# N CITIZENS COMMENTS AND RESPONSES ON THE INITIAL EA

Written comments were received from the following citizens on the initial Environmental Assessment published on October 9, 2013. Their statements and responses to their comments are documented herein. *All personal information has been redacted.*

Illustration 1: Broad Branch Road, would be a great encouragement to bicycle commuting, serving as a "collector" feeding into the Rock Creek Park bike path, if made safe for bicyclists.

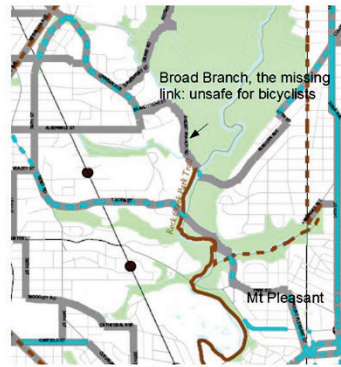
Alternative 3 adds a sidewalk, which in practice would likely become a bicycle path as well. This should be the minimally acceptable approach, opening the road to reasonably safe walking and bicycling. In practice, bicyclists and pedestrians will surely share that sidewalk. Though tolerable, this approach entails bicyclist-pedestrian conflicts. Pedestrians don't like bicyclists flying by, and bicyclist-pedestrian collisions can result in serious injury.

Only Alternative 4 is truly accommodating to both pedestrians and bicyclists. It appears that, compared to Alternative 3, there is no greater loss in trees, and the marginal cost is only about 10% of the total. Given the progressive philosophy of the District today, encouraging commuting to downtown by bicycle, rehabilitation of Broad Branch Road to promote safe use by both pedestrians and bicyclists is clearly the correct choice.
